State Significant Development Application SSD-21208499
Glanmire Solar Farm
Site: 4823 Great Western Highway, Glanmire (Lot 141 in DP 1144786)
Submission on behalf of Fitzsummer Pty Ltd

Cumberland Ecology was commissioned to undertake a peer review of the BDAR and Environmental Impact Statement (EIS) relating to the proposed Glanmire Solar Energy Project. A series of figures reproduced from the BDAR is provided as an attachment to this letter. The figures show:

Figure 1 Location Map

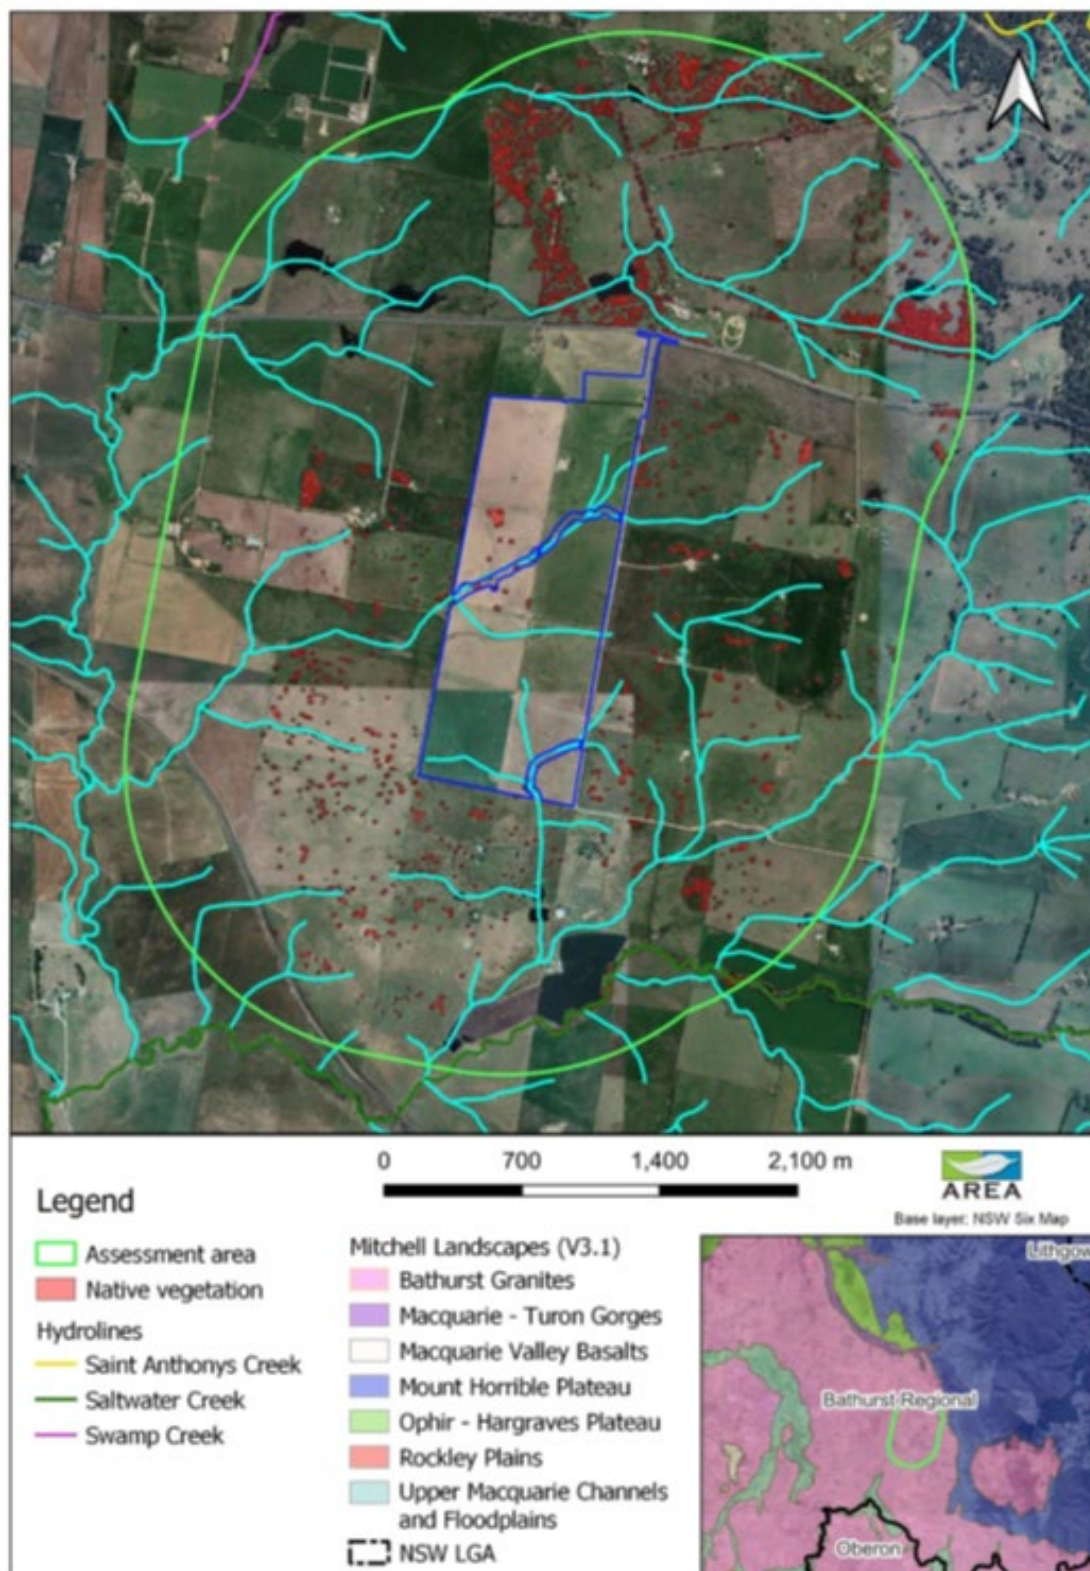
The subject site contains eight non-perennial waterways of first or second Strahler order streams, and one in the south that is a perennial waterway, which is a third or possibly fourth order stream (**Figure 1**). The NSW government has published the Guide to completing and submitting a new or amended controlled activity approval. This guide describes development on waterfront land.

Figure 3 Development layout

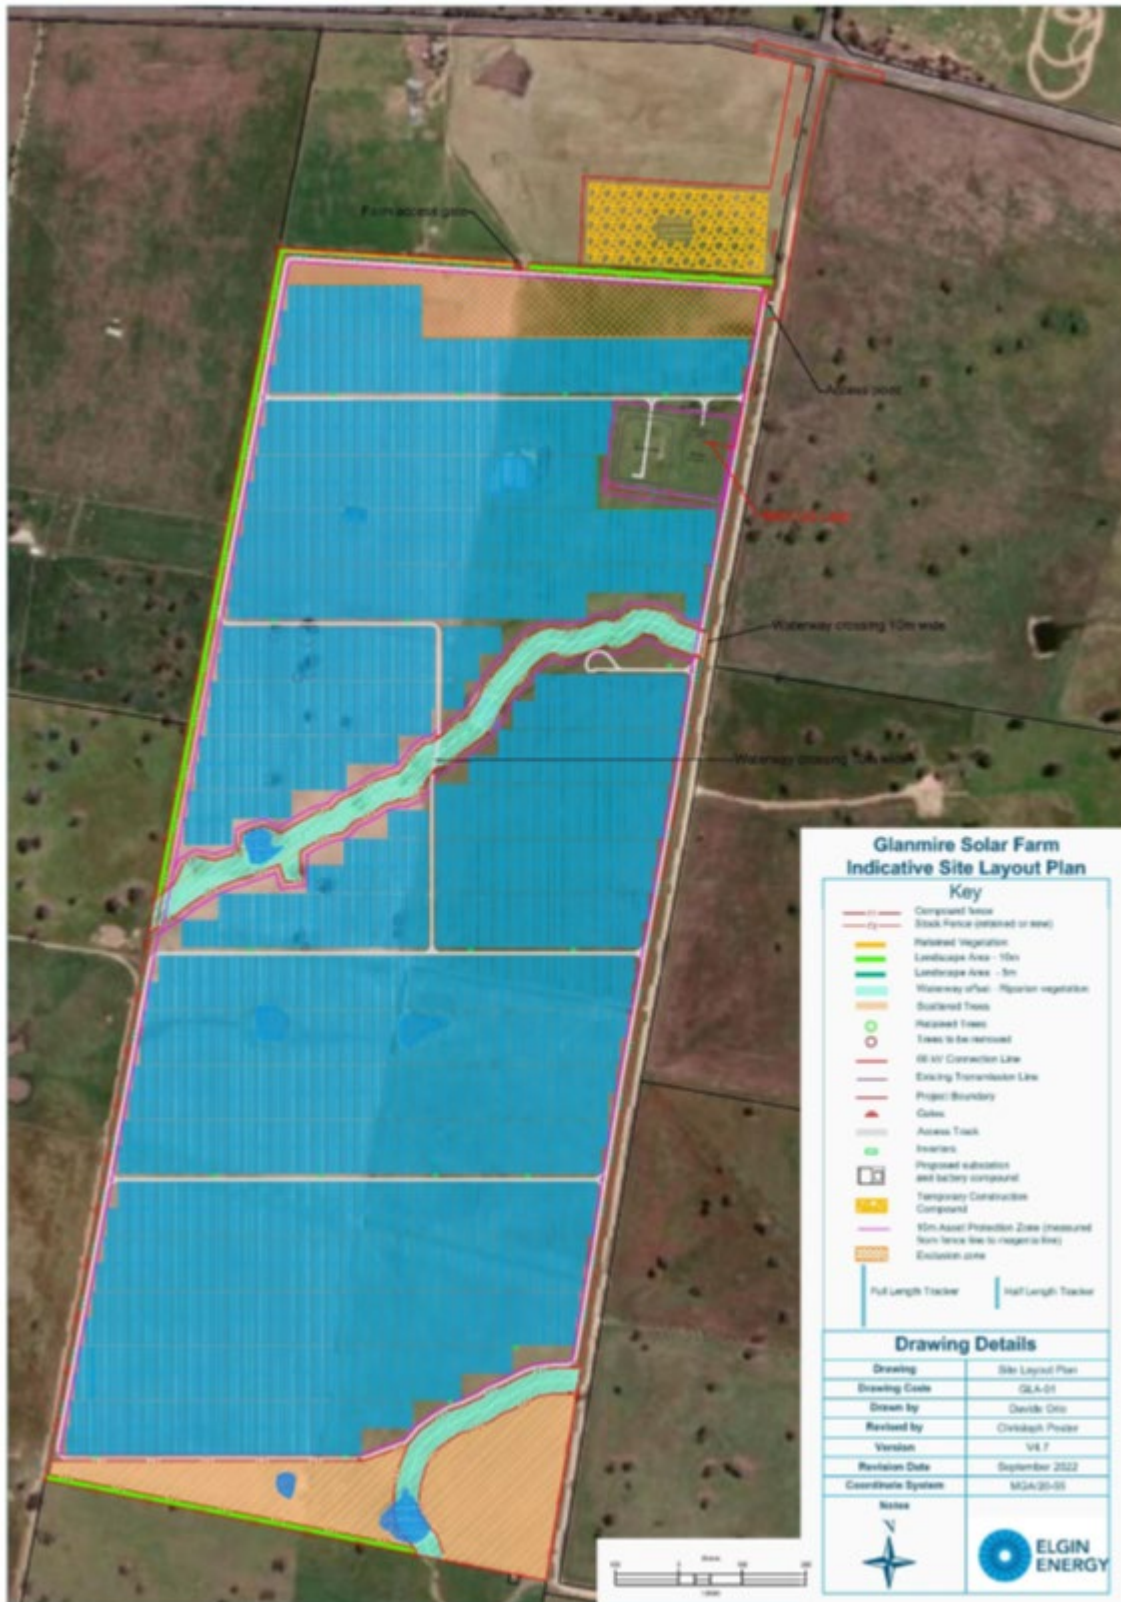
The documentation was prepared to support the construction, operation and eventual decommissioning (over a total timespan of approximately four decades) of a proposed solar farm at Lot 141 DP1144786, in Glanmire, NSW - located approximately 10km east of the centre of Bathurst (**Figure 1**). The proposed design for this project aims to utilise the bulk of the land and can be seen in **Figure 3**.

If implemented as shown in **Figure 3** the major occurrence will be almost entirely cleared. However, there is potential to modify the proposed development design, have less solar panels, and retain the trees, including all hollow trees.

Figure 23 Plant community types

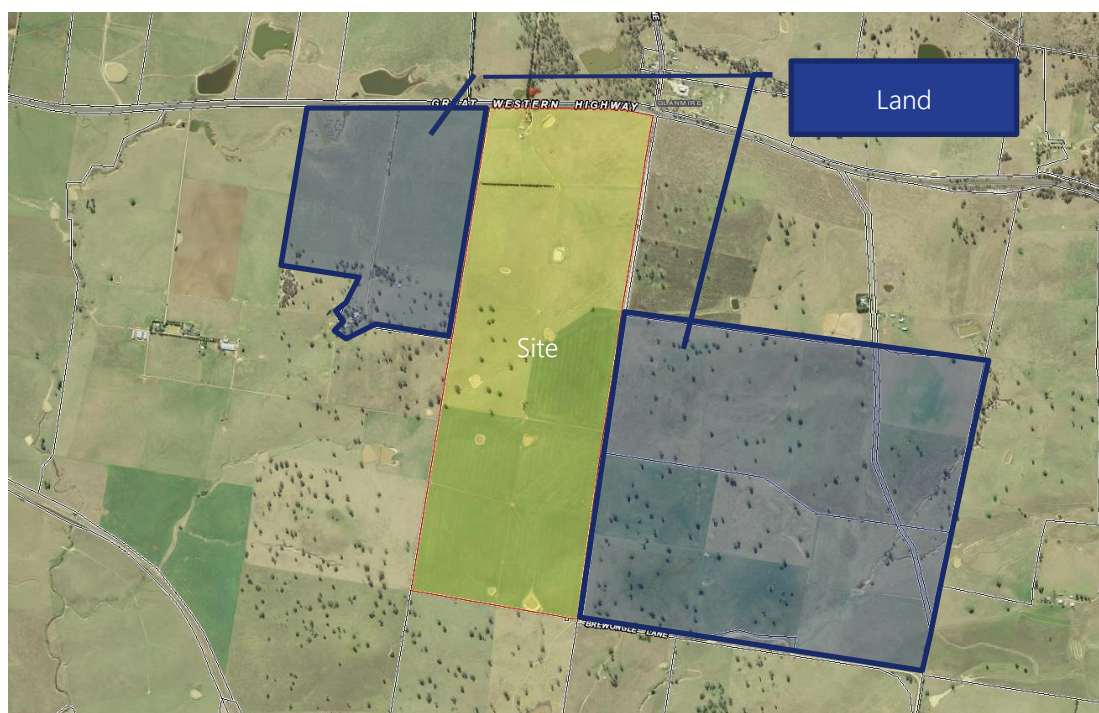
The proposed development will remove two remnant patches of Box Gum Woodland and surrounding scattered trees. In total, 13 trees, including six hollow-bearing trees (HBT) will be removed by the proposed development while only two large HBT will be retained in the riparian buffer that intersects across the subject site (**Figure 23**). Therefore, 6/8 HBT, or 75% of the hollows will be cleared.

In conclusion, the proposed development removes a significant portion of critical habitat on the subject site for the Superb Parrot and Southern Myotis (**Figure 17**). Current literature states that hollows of this size can take over 100 years to form. Consideration must be given to the trade-off, in this case, of reducing the amount of solar panels in this project to protect critical habitat for threatened species. The BDAR fails to discuss this, and therefore fails to engage properly in Avoidance, one of the key principles laid out by BAM 2020.

Figure 6 Extract from Transmission Line Augmentation Works

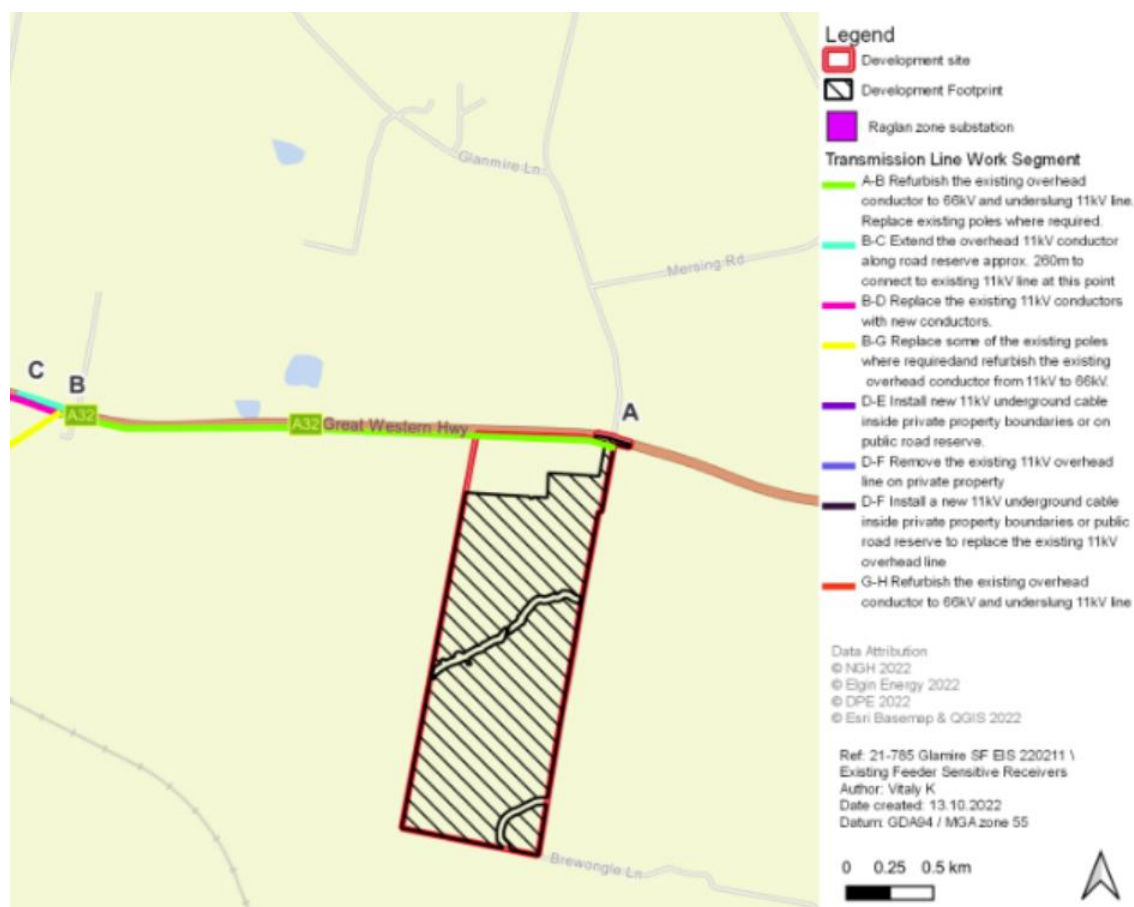
The report has however failed to detail the size or design of these power poles. It is however noted on page 6 of the EIS that the poles will be limited to 18m in height, due to the obstacle limitation surface associated with the airport. Considering the size and scale of the transmission lines currently running on Old Bathurst Road, the refurbishment of these poles to 66kV containing poles of a height of 18m would have a significant visual impact that has not been represented or considered in the visual analysis undertaken.

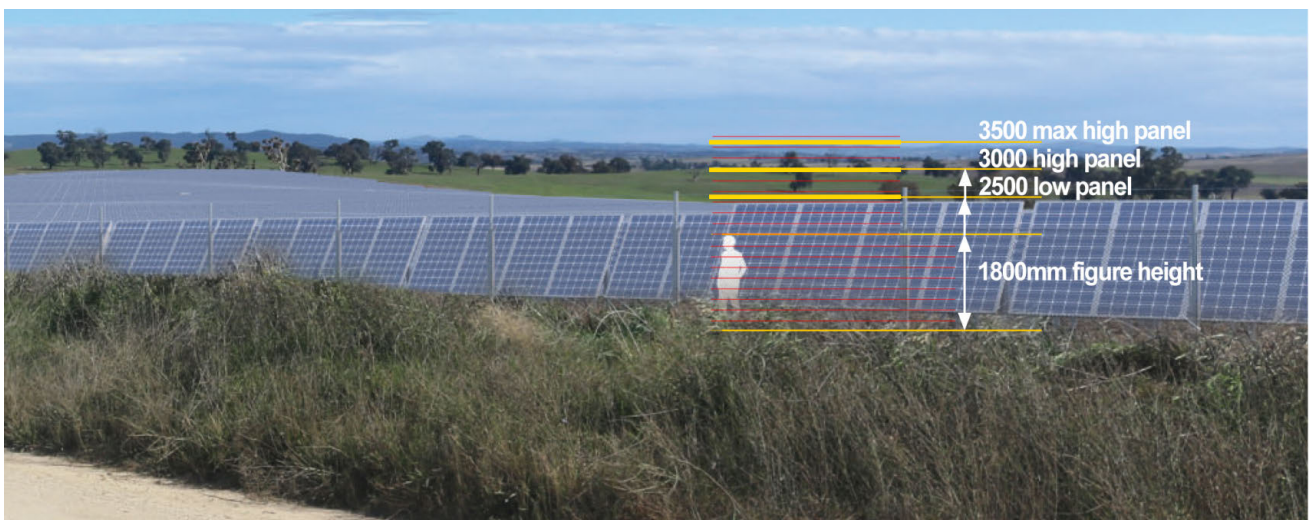
This diagram, from the Iris report, shown the alignment of the CAD / LIDAR 3d model onto the background photograph. However, it can be seen that the alignment is only approximate, with the existing treetops still visible above the overlay. This will result in a CAD model position lower than a true representation. See below for a closer view of the misalignment:

Although this discrepancy could be observed as minor, it is of the order of several metres at such a distance that the impact is far greater in the foreground, which is of greater relevance.

Figure B12: Viewpoint 1: View south from Brewongle Lane, magnitude analysis
Date: September 2022

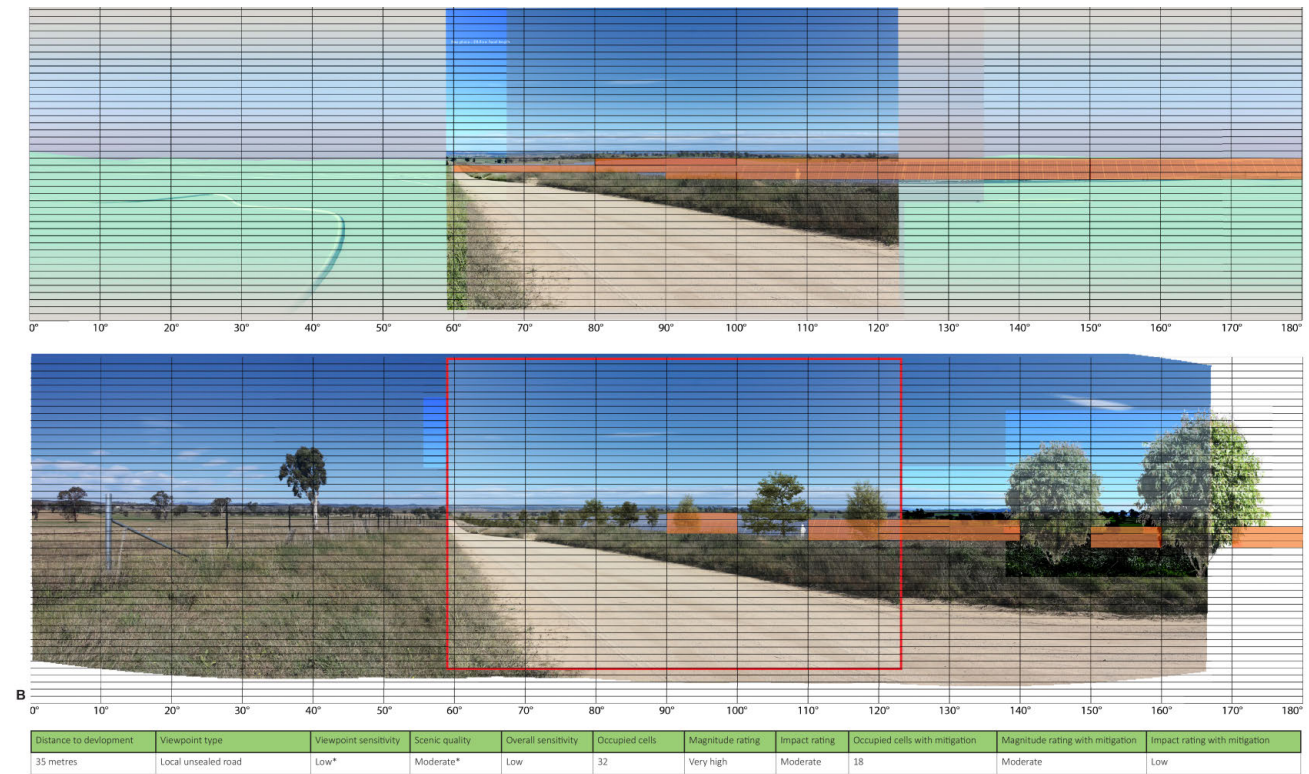
This version of VP1 indicates the site with mature landscape. It can be observed that the valuable component of the view, the rolling hills to the south, are obscured by the imposed landscape, while a large portion of the panels remain visible through the trees. Also, the depiction of the security fence in all images is significantly underestimated, as already noted. The mitigation measures, including the continuous, relatively orthogonal, line of trees, serves to create another non-natural feature within this very random landscape and is discussed later in this review. The formality of the planting does not relate to the surroundings and a more undulating layout, within the parameters of the planting zone could be considered.

The magnitude analysis diagram, above, indicates a diminishing visibility of the panels and fence. However, these items remain visible, particularly if deciduous trees and vegetation are incorporated. The second analysis diagram does not reflect this, instead removing any panel indication that contain even a portion of landscape, which should not be the case. Rather, when a portion of the panels remains visible, the coloured block should remain active.

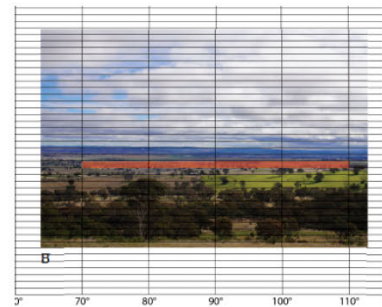
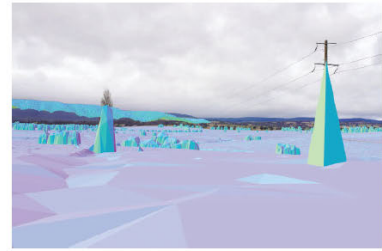
The Glanmire Solar Farm fact sheet from October, 2022, suggests the new poles will be between 2m and 6m higher than the existing and with larger conductors, as shown below.

Within the views along the Great Western Highway, consideration should have also been given to the upgraded utility poles that will accompany the development. These are higher than the existing poles and made of concrete – see attached for an estimated visual comparison.

Since this is one of the two 'gateway' access roads to Bathurst, the visual impact of larger utility poles should have been considered within the visual impact assessment. In addition to their size, the likely use of concrete, because of their size, introduces another man-made element into the scene.

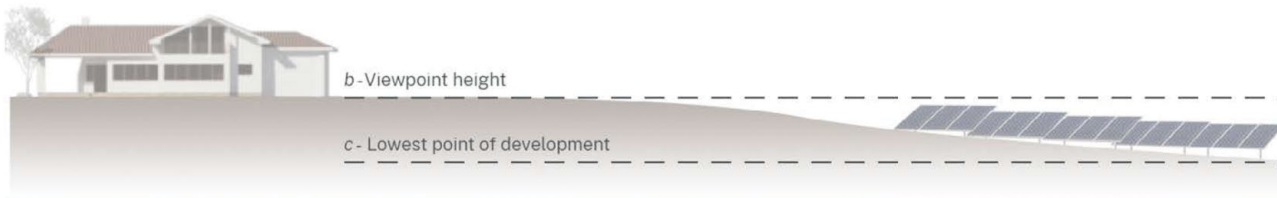
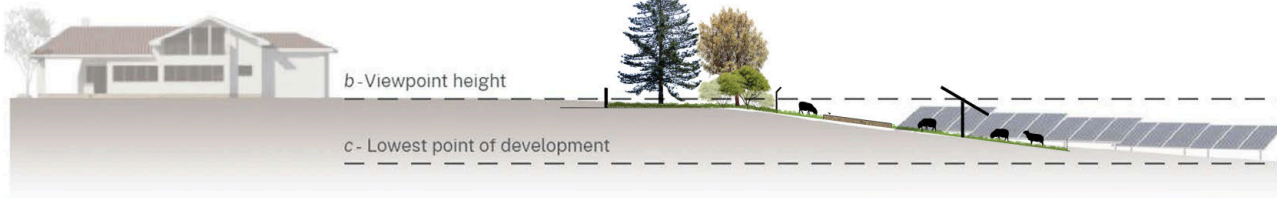
Within the IRIS report, preliminary assessments, regarding the visibility of the installation have dismissed many residential receptors as being unaffected by the proposal. However, this ignores that the potential landscape mitigation measures as being an integral part of the overall scheme. This will, in almost all instances be visible, even if the panels are not – see section below for on overlay of the landscape barriers upon a 'non-impacted' house.

Here, the preliminary assessment suggests no Impact.

However, the visual impact / view loss will still be observed by the resident as a result of the mitigation landscaping. This will be required to satisfy other receptors, but impacts on this one also.

Current recommendation for mitigating landscape to the western boundary of the site.

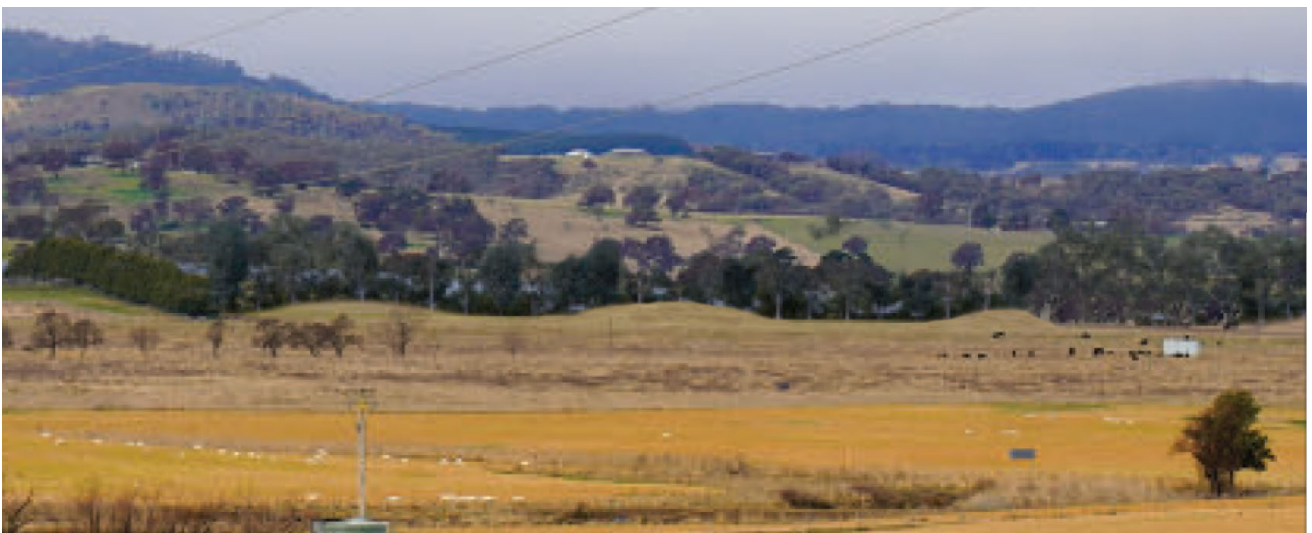
Furthermore, the screening proposal is not responding to the existing landscape, which consists of gently undulating land and random groups of trees and individual trees. By providing a continuous line of screening trees, the impact is a relatively 'unnatural' one. The recommendation would be to include selective locations for land mounding, allowing a breakup of the continuous tree line and a more responsive solution to the site and to the problem of concealing the panels. The interspersed solid earth mounding will also serve to break up the potential for glare impact in a continuous, albeit filtered, line.

See an example below of a mixture of tree screening and mounding, seeking to break the continuous line of the current mitigation proposal, in comparison to the current proposal, with little variation in height, or scale and a stark imposition upon a very gentle landscape.

The same view with small undulations in the landform and a variety of tree heights that correspond to this.
